# Access Compliance Report

## Public Rights-of-Way

Intersection ID: N/A	Main Street: YORK_CENTER	Cross Street: N/A	Location: SE
ADA ID: 4C9C5C2C30BB	Ramp Type: BlendTrans1	Initial Pass/Fail: Pass	Overall Compliance: No
		Severity Score: 0.25

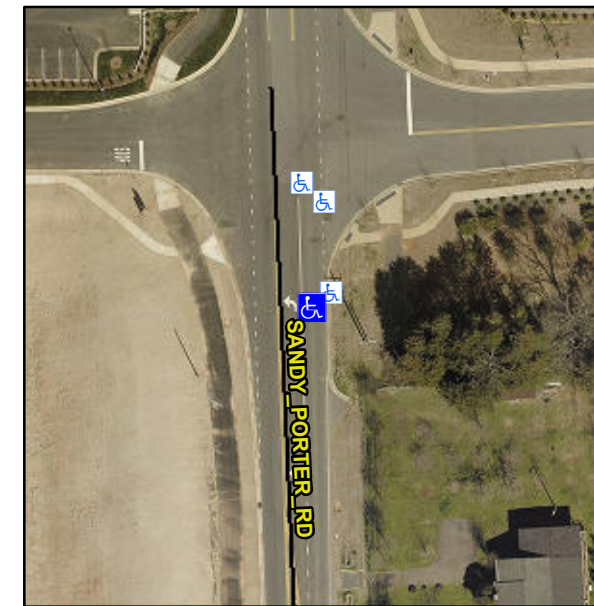
**Not Found, R304.5.3, R304.2.2-Perp, R304.3.2-Para, R305.2**

Compliance	Description	Data	Compliance	Description	Data
N/A	Ramp Length (in)	72.0	Yes	BlendTrans Slope (%)	2.4
Yes	Ramp Width (in)	60.0	No	BlendTrans XSlope (%)	3.4
N/A	Flare Type LT	Sloped	N/A	Flare Type RT	Sloped
N/A	Flare Slope LT (%)	2.8	N/A	Flare Slope RT (%)	7.2
N/A	Flare Traversable LT?	No	N/A	Flare Traversable RT?	No
Yes	Landing Length (in)	62.0	Yes	DWS Provided?	Yes
Yes	Landing Width (in)	60.0	Yes	DWS Contrast?	Yes
No	Landing Slope (%)	5.0	Yes	DWS Length (in)	24.0
Yes	Landing X Slope (%)	1.1	Yes	DWS Full Width?	Yes
N/A	Landing Curb? (Y/N)	No	No	DWS Offset (in)	3.0
N/A	Shared Landing?	No			
Yes	Gutter Ponding?	No	Yes	Gutter Slope (%)	3.2
Yes	Gutter Lip Ht (in)	0.0	Yes	Gutter X Slope (%)	2.0
N/A	Painted X Walk1?	No	N/A	Painted X Walk2?	No
	X Walk 1 Direction	To N		X Walk 2 Direction	To W
	X Walk 1 Width (in)	N/A		X Walk 2 Width (in)	N/A
	X Walk 1 Slope (%)	0.6		X Walk 2 Slope (%)	4.2
	X Walk 1 X Slope (%)	5.0		X Walk 2 X Slope (%)	1.2

**Remove & Replace Curb Ramp With Two New Directional Ramps or Equivalent.**
